TOWN OF WINCHENDON

BOARD/COMMITTEE: **Planning Board – Regular Meeting &
PUBLIC HEARING - Continued**

1. Call to Order
 - Pledge of Allegiance
2. Announcements
3. Public Comment
4. New Business:
 - A. **6:35 pm - PUBLIC HEARING CONTINUED** - Site plan application for a 3.135 MW DC Ground-Mount Solar Development on property located at 185 Baldwinville Rd., (Map 13 Parcel 04). PAGE 2

Tighe & Bond has been retained by the Town of Winchendon to provide Peer Review Services to the Planning Board in their review of the Site Plan Review and Low Impact Design Permit Applications for the construction of a 3.135 MW photovoltaic solar array (the Project). The Project is located on an approximately 51.182-acre parcel of land located at 185 Baldwinville Road in the Town of Winchendon, Massachusetts. The property is located within the Rural Residential (R-80) zoning district, according to the latest Zoning Map, dated November 2, 2009. The Applicant, Sunpin Solar Development, LLC, has provided the following documents for review:

Current Dec. Design

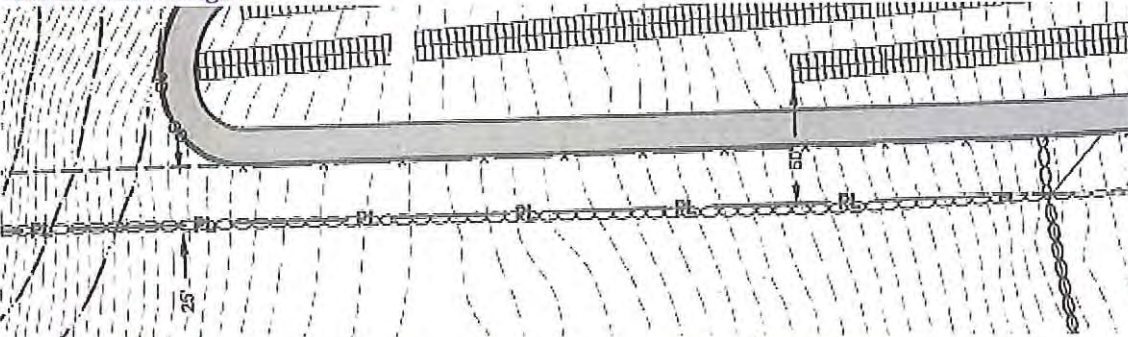
Regarding the southern buffer you mentioned, on the design review plan the panels originally went right up to the 25-foot buffer line (with the fence less than 25' from the property line). As shown on the 12/17 submittal drawing, the perimeter road was added, and panels pushed back to 50' from the property line. See screenshots below:

PROPOSED SITE PLAN
 3.135 MW DC GROUND-MOUNT SOLAR PV DEVELOPMENT
 185 BALDWINVILLE RD
 WINDHAM, MASSACHUSETTS

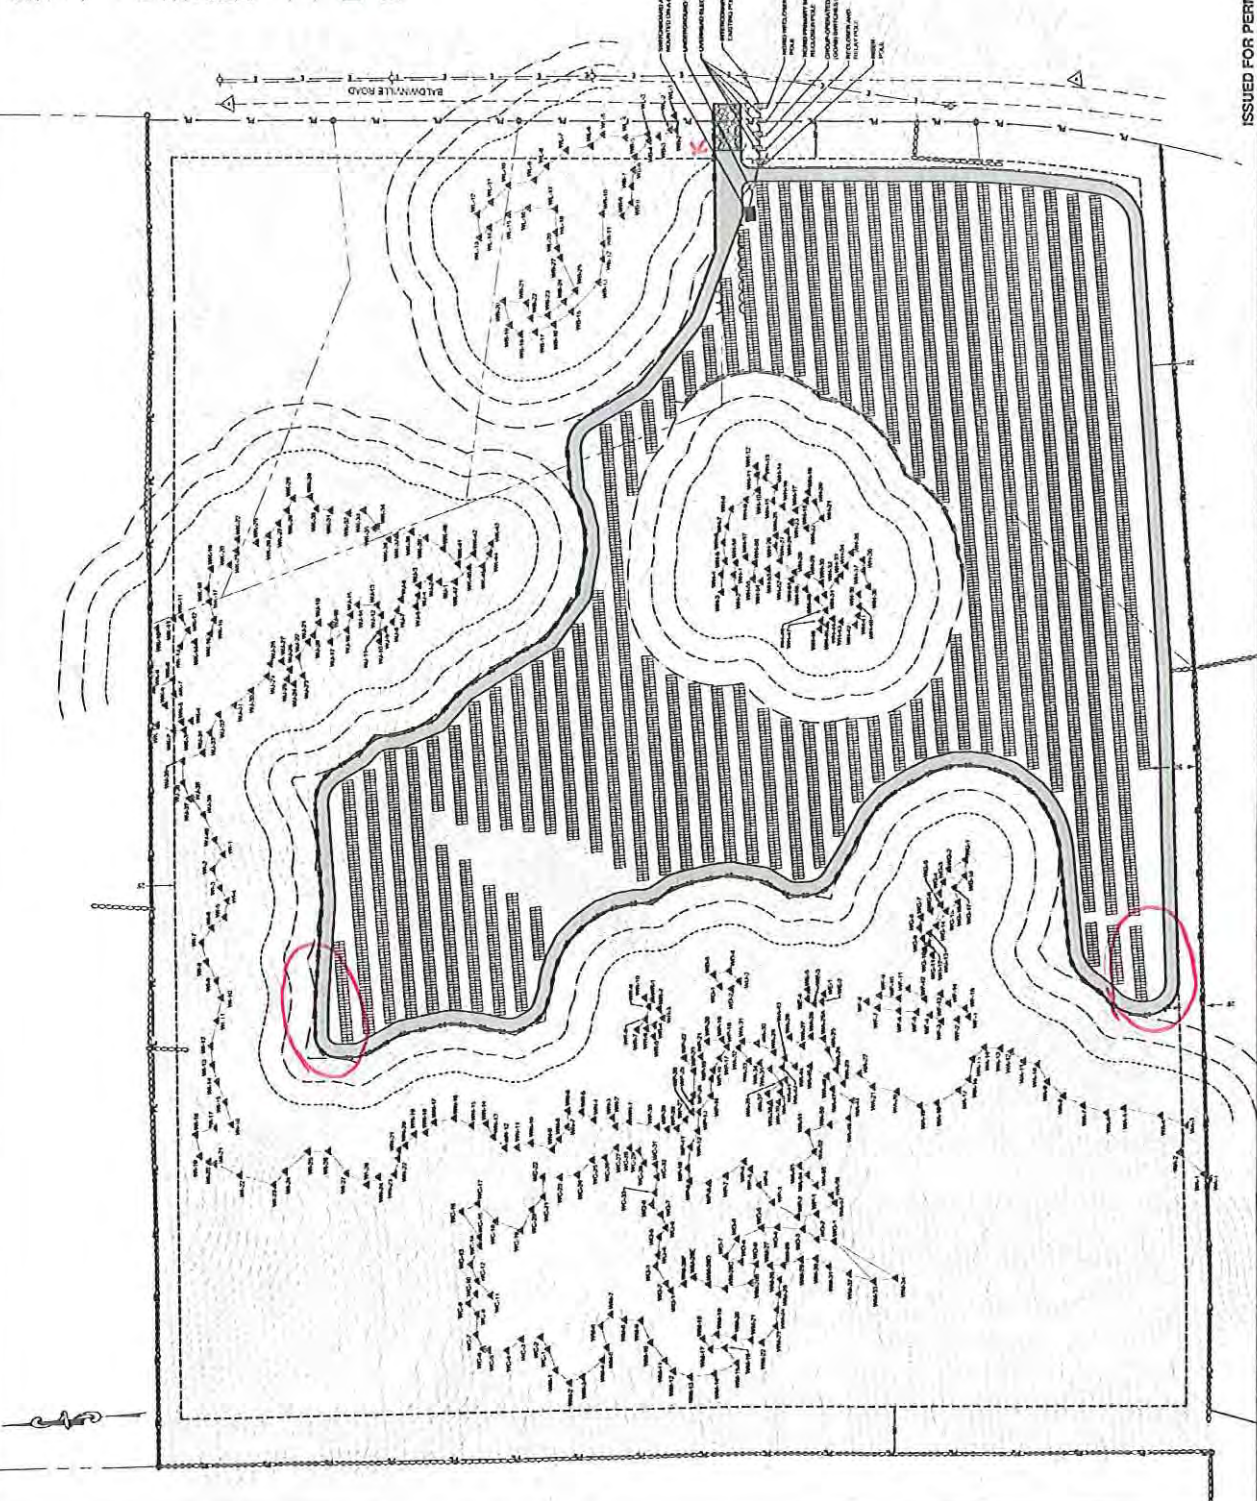
- A "Knox" box and key access to the entry gate for the department. (Marked with red "K" on the plot plan)
- Provision for a fire department orientation at the site once the project is complete showing the location of the disconnects and other equipment.
- Adequate entry access to the site and around the outer sections of the project for a brush truck. This access around the project only needs to be hard packed enough for a brush truck. (It is understood that due to the elevations it would not be possible completely around the project. Instead the fire department would be comfortable with there being two turnarounds in the area of the "red circles" on the plot plan.)
- Ability to turn an ambulance around within the site.
- Appropriate ongoing maintenance of brush/grass in the proximity of the solar array.
- Accurate contact information throughout the project.

Figure 1: Red-line exhibit depicting amendments

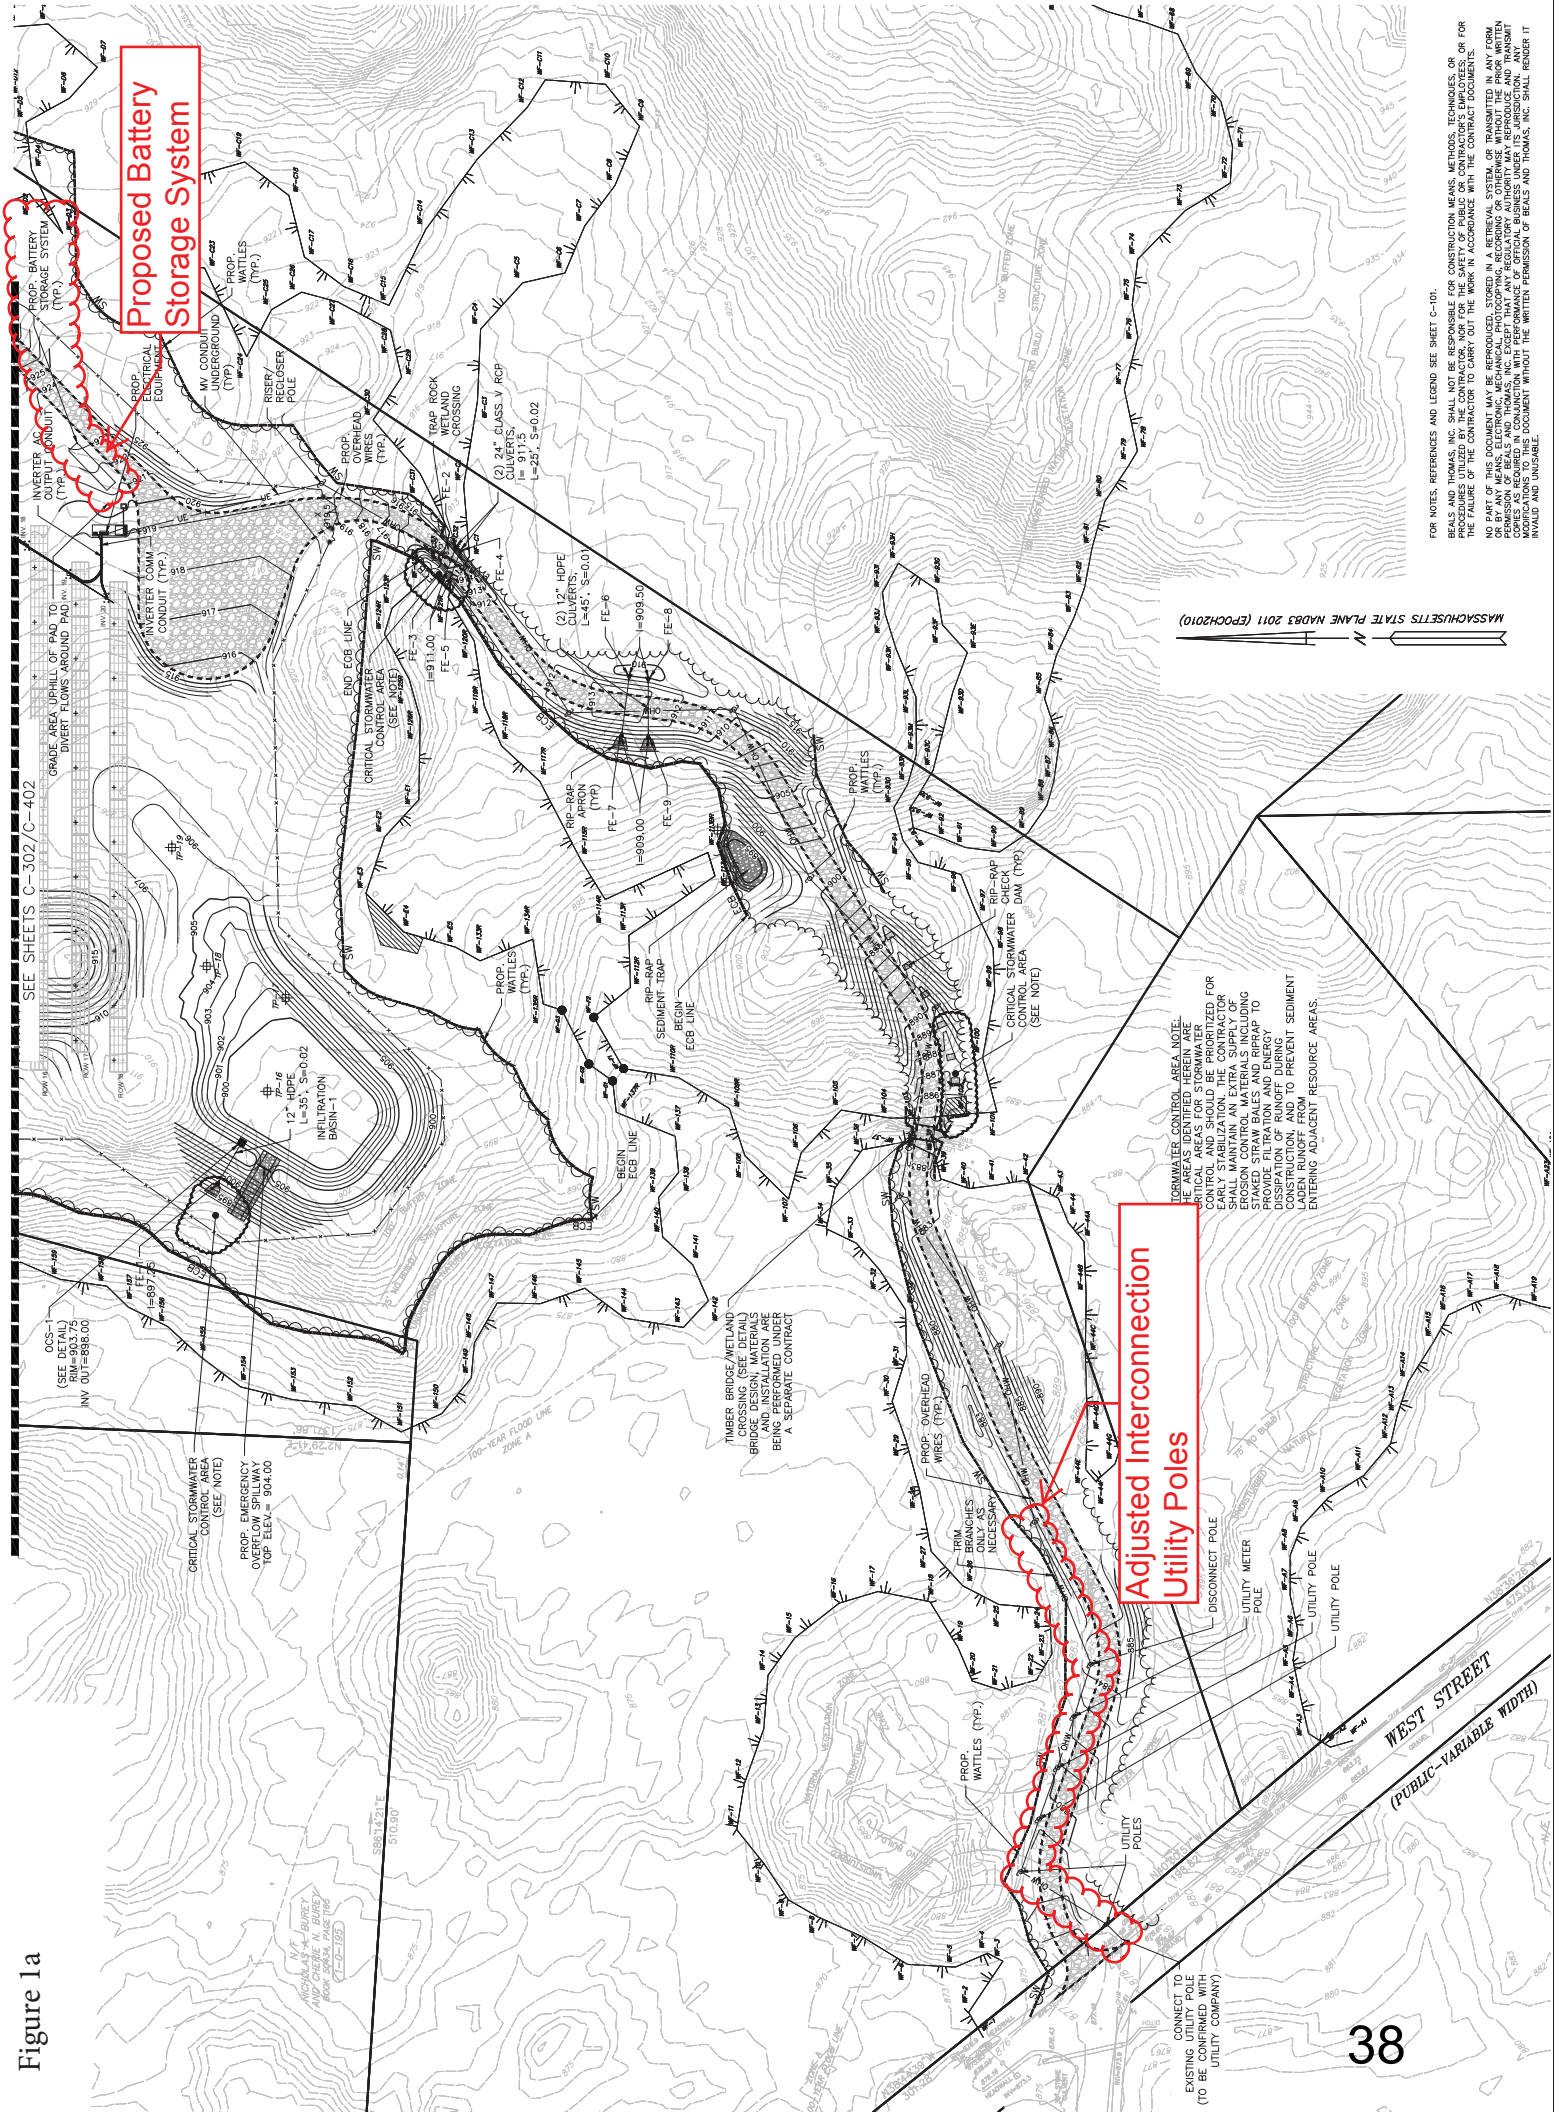
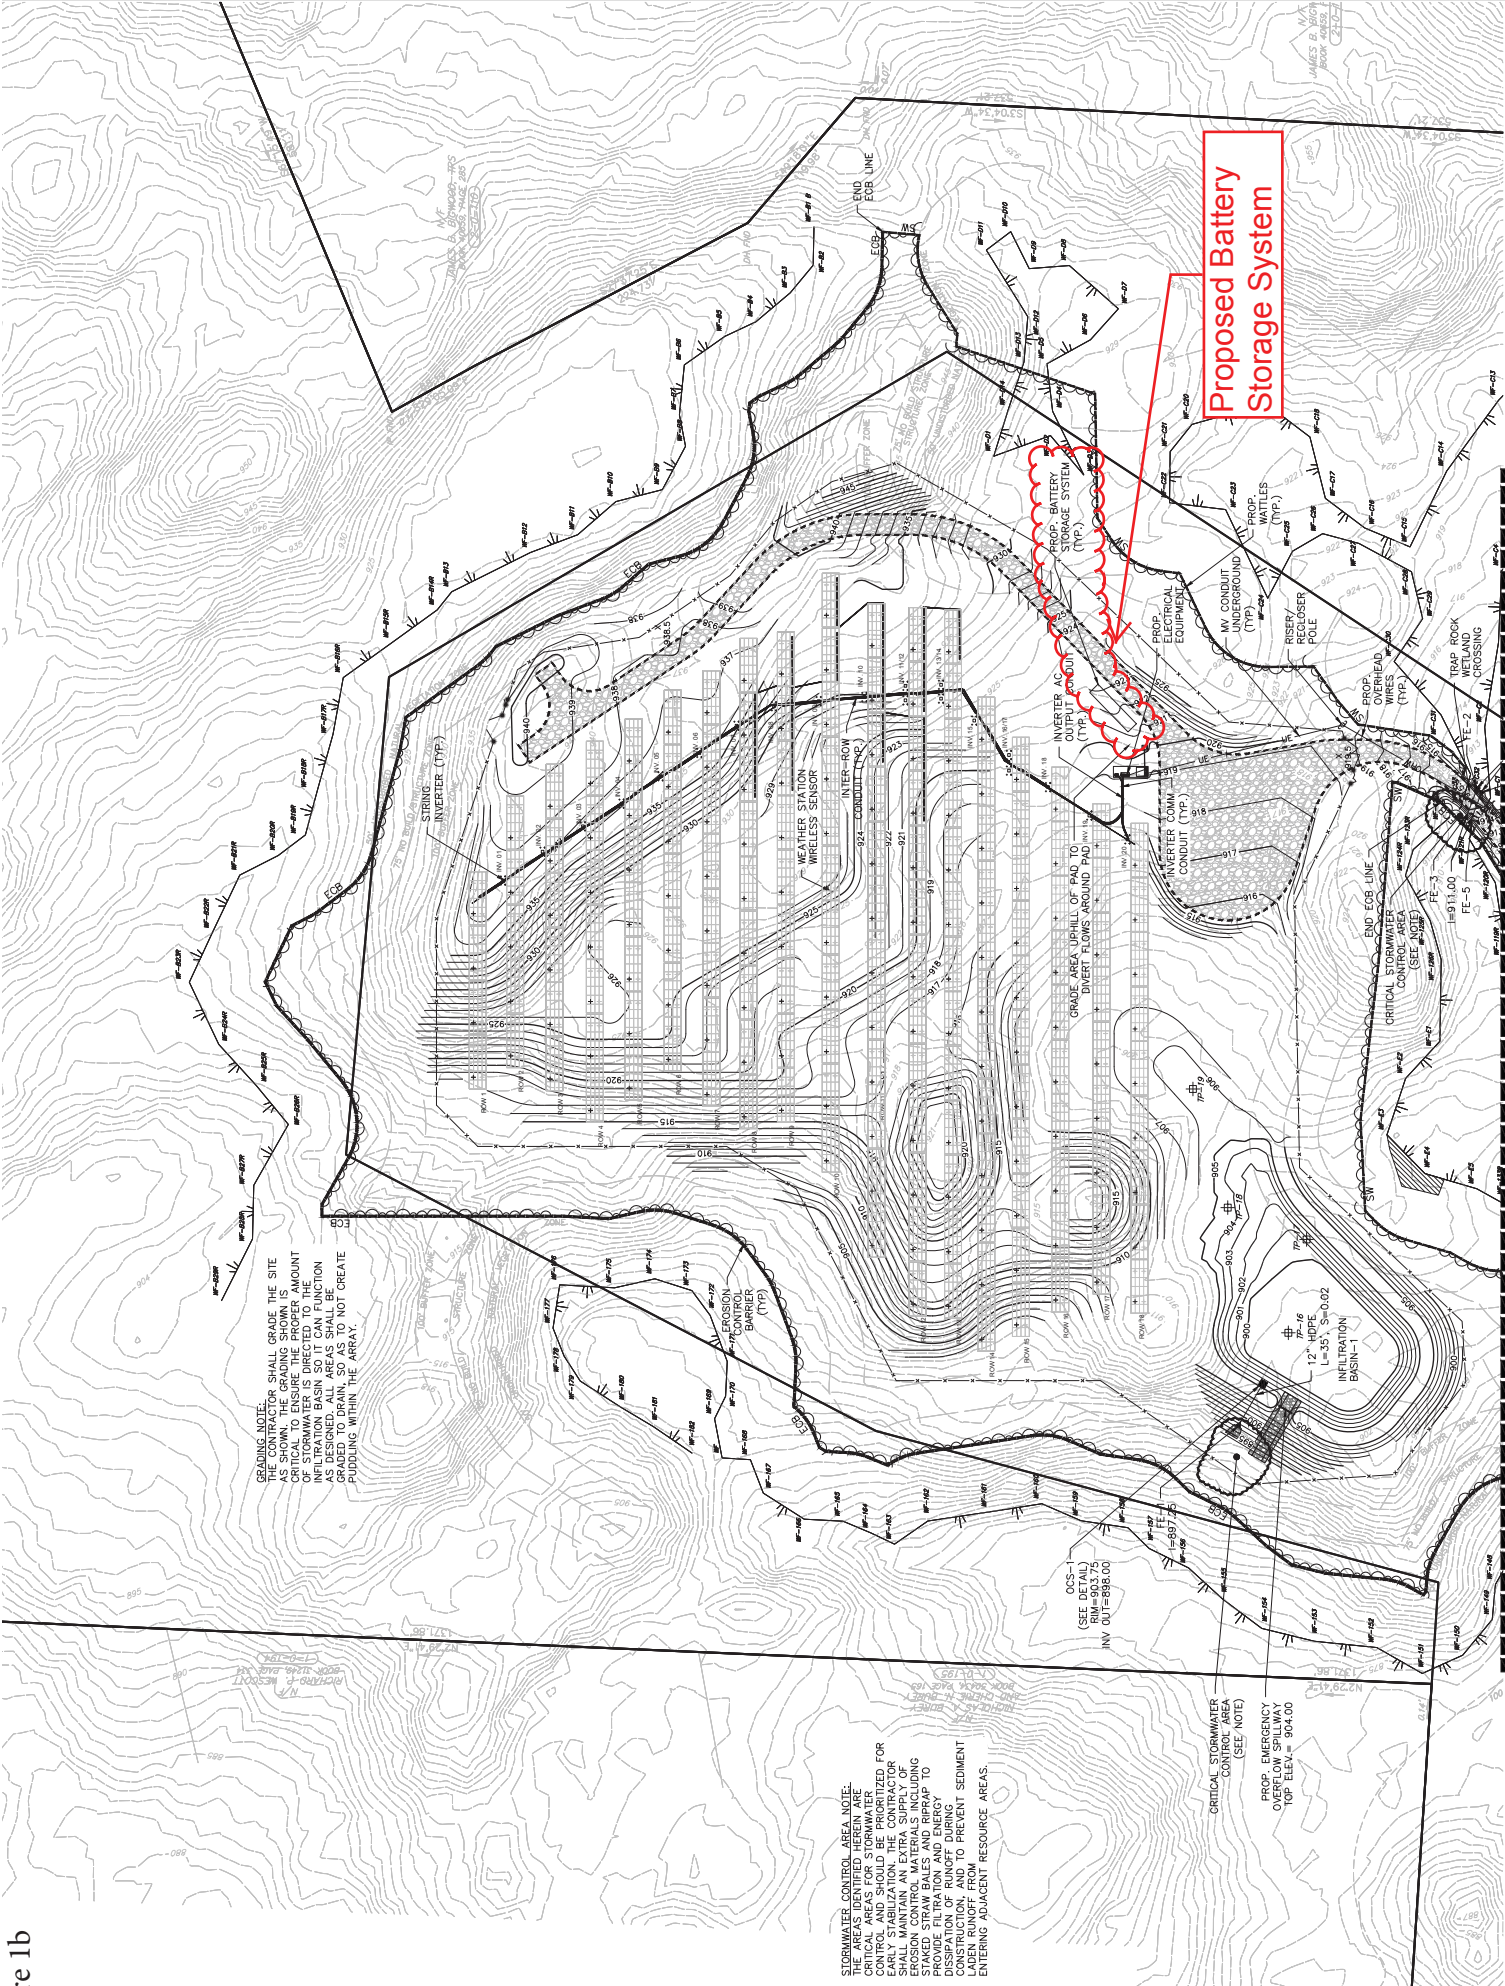
The Applicant currently proposes to add a battery storage system to the Project in an effort to more efficiently provide power to the electric grid. The battery system is capable of delivering 0.5 MW of energy over two hours, which helps to meet peak energy demands later in the day as solar production diminishes. The battery storage system would be housed within a metal enclosure slightly elevated on concrete footings, and will contain a fire detection and suppression system. Please refer to the documentation of the battery storage system components included in Section 2.0 for system dimensions, as well as the revised site plans enclosed in Section 4.0.

In addition to the proposed battery storage system, the Applicant proposes minor adjustment to the array layout, as well as the number and location of the interconnection utility poles along the access road, as depicted on the enclosed revised plans. The locations of these poles as currently depicted were specifically requested by National Grid, which will own and maintain the poles. The closest pole to adjacent wetlands is approximately 30 feet. Clearing beyond the approved tree line in the vicinity of the wetlands is not required to accommodate the adjusted pole locations. The minor adjustments to the pole number and location is not anticipated to increase visibility of the interconnection from West Street. As such, no new aesthetic impacts are anticipated.
